March 8, 1985
ST-HL-AE-1202
File No.: G9.17/G9.10

South Texas Project
Units 1 & 2
Docket Nos. STN 50-498, STN 50-499
NRC Request for Additional Information

MAIN FEEDWATER ANTI-WATER HAMMER PROVISIONS

AXILIARY FEEDWATER INTERFACE

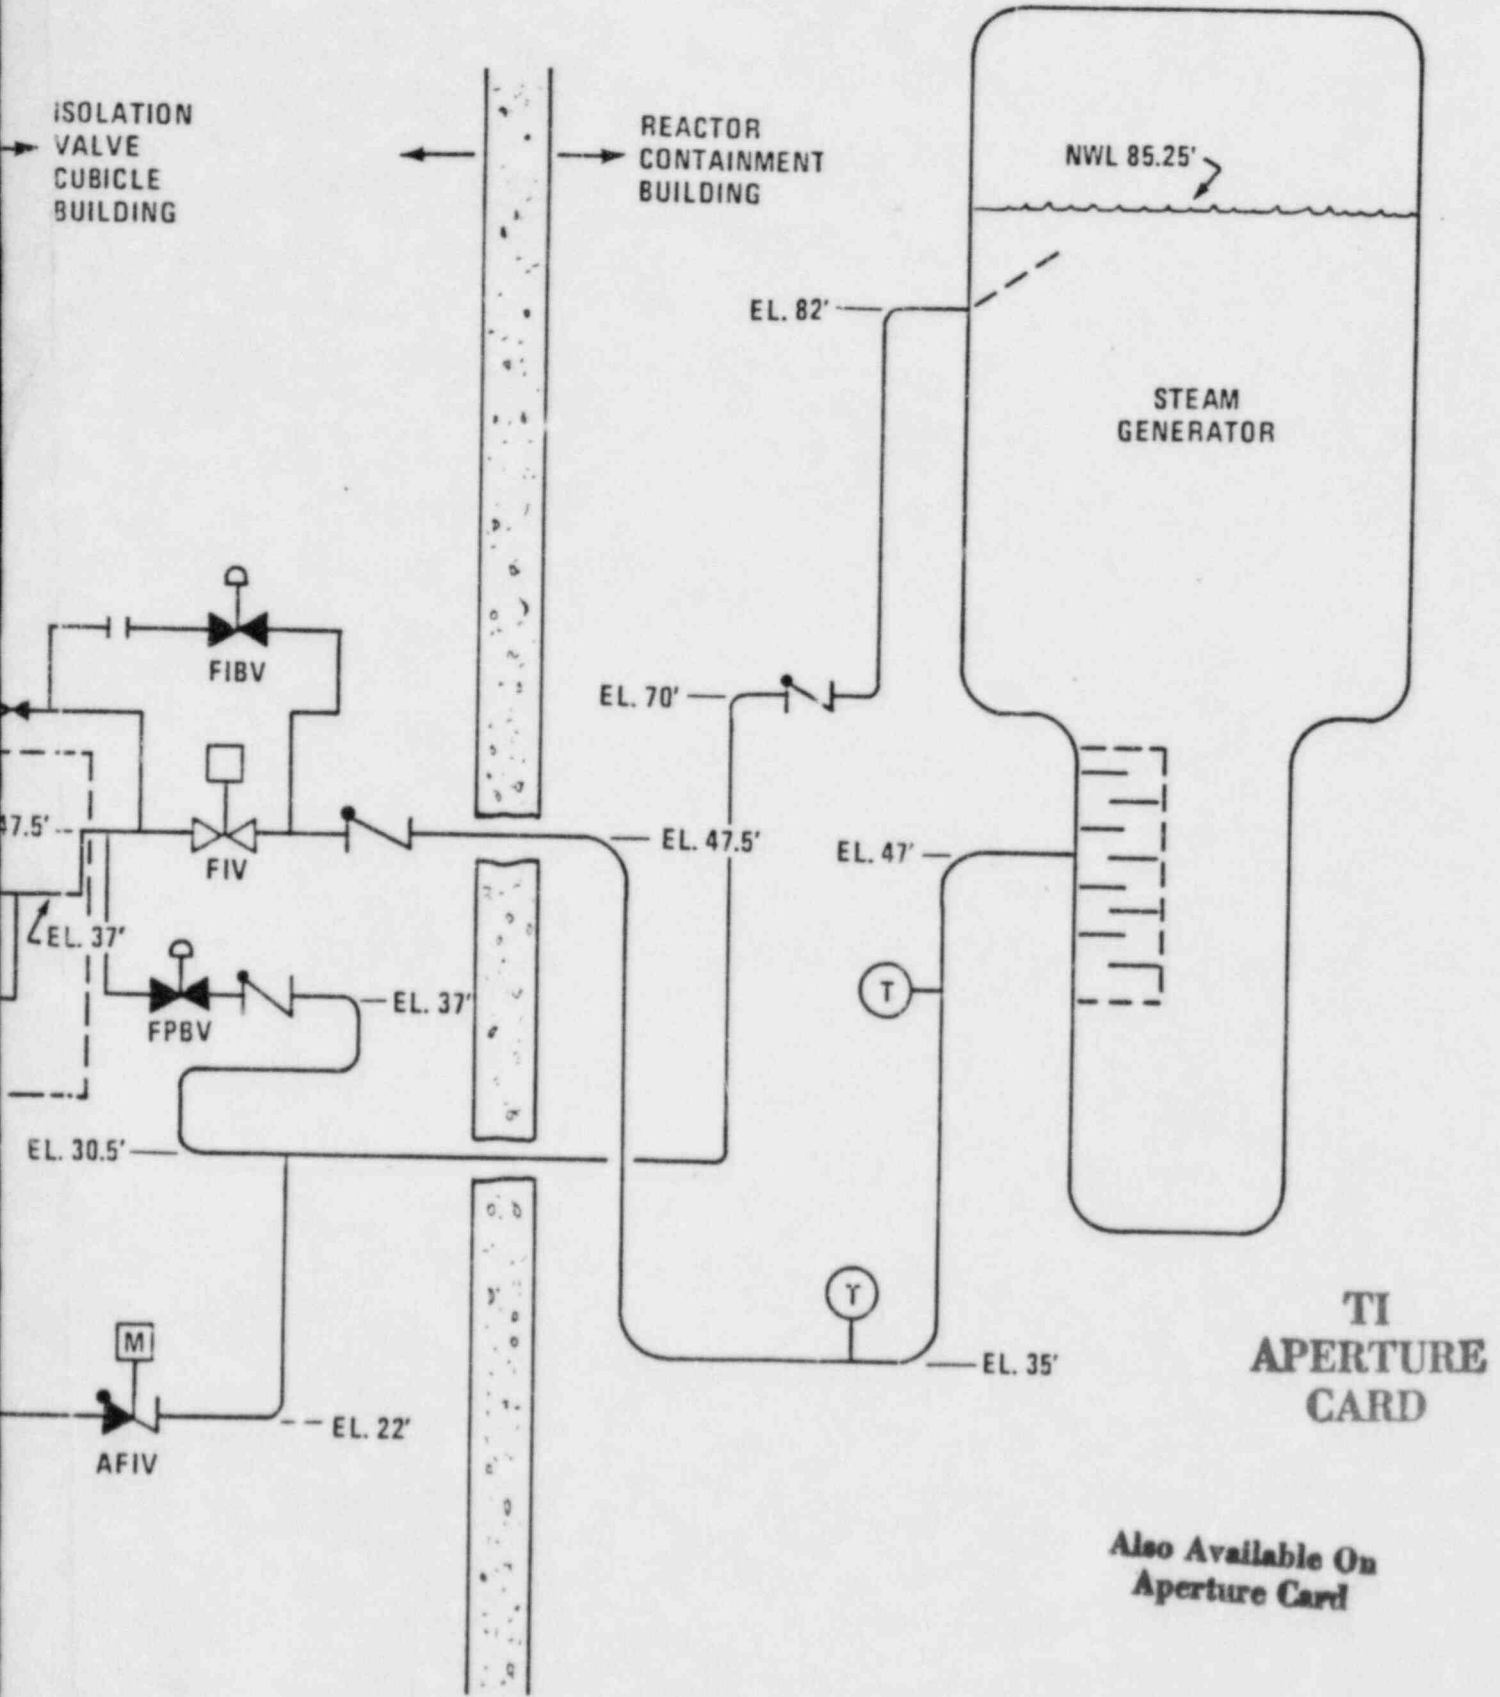
Provide detailed justification/documentation to show that eliminating arbitrary intermediate pipe breaks in the main feedwater system will not impact the safety of the plants because of special design features and operating procedures adopted by the South Texas Project to preclude or minimize the effects of water-hammer in that system. An acceptable level of detail on this issue is contained in Attachments F and G to a letter from D. E. Swartz, Commonwealth Edison to H. R. Denton, NRC, "Byron Station, Units 1 & 2 - Elimination of Arbitrary Intermediate Pipe Breaks", dated November 15, 1984.

The STP Feedwater (FW) system design includes provisions to prevent the condensation-induced water hammer in both the feedwater piping and Steam Generators (S/Gs). Westinghouse (W) concurs that the STP design is in general compliance with the W proposed Main Feedwater Temperature Pegging System. The specific STP anti-water hammer design considerations are described below. (See the STP Main/Auxiliary Feedwater Interface diagram attachment 4).

The STP Auxiliary Feedwater (AFW) system design features that reduce the potential for condensation-induced water hammer are described below. (See the STP Main/Auxiliary Feedwater Interface diagram attachment 4).

- 1) The STP AFW system consists of four independent trains that are normally not cross-connected. This eliminates the potential for steam binding or water hammer affecting more than one train from a single event.

- 2) The STP programmed water level is above the AFW (upper) nozzle internal extension during all NSSS load conditions. The auxiliary feedwater piping will not drain as a consequence of low SG water level because of the internal extension. These provisions assure that the nozzle and upstream piping will not fill with steam.

- 3) The STP AFW horizontal piping immediately upstream of the SG nozzle is minimized, with a down turned elbow located near the SG consistent with Westinghouse recommendations.

- 4) The Auxiliary Feedwater isolation valve (AFIV) is a normally closed stop check valve that opens on an AFW actuation signal. This normally closed valve prevents backleakage to the AFW pump train during low load operations when using the FW/AFW crossconnect. Likewise during normal power operation the AFIV in combination with the normally closed FPBV seal the AFW piping upstream of the AFW check valve inside containment, this "bottles" the upstream piping not allowing backflow.

- 5) The AFIV and the FPBV being containment isolation valves will be on a scheduled maintenance and leak testing program. The other FW and AFW check valves will be maintained to minimize backleakage.

- 6) Consistent with Westinghouse recommendations, there are at least two check valves in each flow path by which backleakage could occur into the Auxiliary feedwater or Main Feedwater System.
